Diversion of 3.7463 hectares of forest land in favour of Chamba Hydro Ventures, Hotel Alps Resorts, PO and Tehsil Dalhousie, District Chamba HP for the construction of Ghatore Top SHEP (4.98M.W.) within the jurisdiction of Bharmour Forest Division Distt. Chamba HP (Online Proposal No. FP/HP/HYD/155802/2022)

In reference to Online Proposal No. FP/HP/HYD/155802/2022 EDSs raised by Nodal Officer-Cum-PCCF (FCA) Letter No. 48-5745/2022(FCA) dated 26.05.2025 on the subject cited above.

Subject :- Diversion of 3.7463 hectares of forest land in favor of Chamba Hydro Ventures, Hotel Alps Resorts, PO and Tehsil Dalhousie, Distt. Chamba HP for the construction of Ghator Top SHEP (4.98MW) within the jurisdiction of Bharmour Forest Division Distt. Chamba HP (Online Proposal No. FP/HP/HYD/155802/2022) and Reply to observations thereof.

DIVERSION OF 3.7463 HAC. OF FOREST LAND FOR CONSTRUCTION OF GHATOR TOP SMALL HYDRO
PROJECT 4.98 MW IN TEHSIL BHARMOUR, DISTRICT CHAMBA (H.P.)
FILE NO : TP/HP/HYD/156608/2022
DATE OF PROPOSAL : 9/6/2022

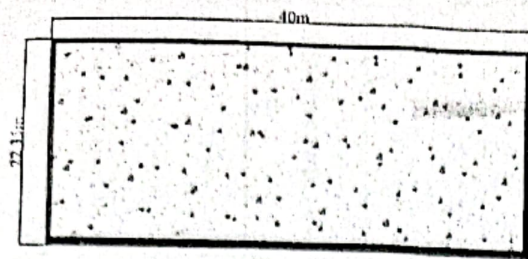
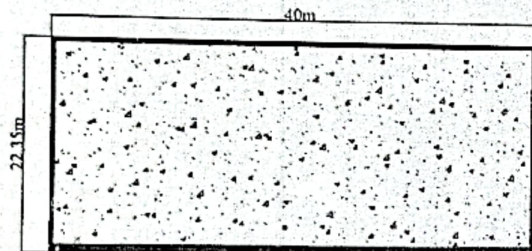
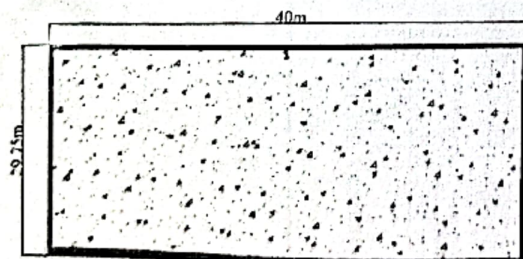
3	The requisite documents/KML file with reference to point no. 6, 8, 11(ii&iv) are not found uploaded. While the situation of uploaded documents i.e Sr. No., Column. Part etc are to be mentioned in forwarding memo.	1. Reply to Point No. 6 The detailed list of approved/existing/proposed projects in the river basin area has been uploaded with maps and their distance from nearest PA/ESZ. The KML file cannot be uploaded in the portal So mailed to your kind office Please. 2. Reply to Point No. 8 The detailed and approved evacuation Plan along with Transmission Line detail has been uploaded on Portal. 3. Reply to Point No. 11 (ii & iv) (ii) The complete muck Dumping Plan with

areas to reduce ecological impact. 3. Reply to Point No. 11 (i) 1. The number of muck dumping sites proposed within the forest area has already been kept to the bare minimum, based on engineering feasibility, slope stability, and safety considerations. Consolidation into a single site is not viable, as it may lead to overloading, slope failure, and higher risk of siltation in streams. Multiple smaller sites allow for scientific containment, phased stabilization, and effective reclamation with different suitable technology.
3	The requisite Documents/KML file with reference to point no. 6, 8, 11(ii & iv) are not found uploaded. While the situation of uploaded documents i.e Sr. No., Column. Part etc are to be mentioned in forwarding memo.	1. Reply to Point No. 6 The detailed list of approved/existing/proposed projects in the river basin area has been uploaded with maps and their distance from nearest PA/ESZ. The KML file cannot be uploaded in Part-I on Parivesh Portal by User Agency. So mailed to your kind office Please. Reply to Point No. 8 The detailed and approved evacuation Plan along with Transmission Line detail has been uploaded in Part-I on Parivesh Portal by User Agency. 2. Reply to Point No. 11 (ii & iv) (ii) The complete muck Dumping Plan with their capacity of muck dumping and duly authorised by DFO has been uploaded in Part-I on Parivesh Portal by User Agency. (iv) There are no trees standing in the Dumping sites and certificate of NO TRESS IN DUMPING SITES duly authorized by DFO has been uploaded in Part-I on Parivesh Portal by User Agency.
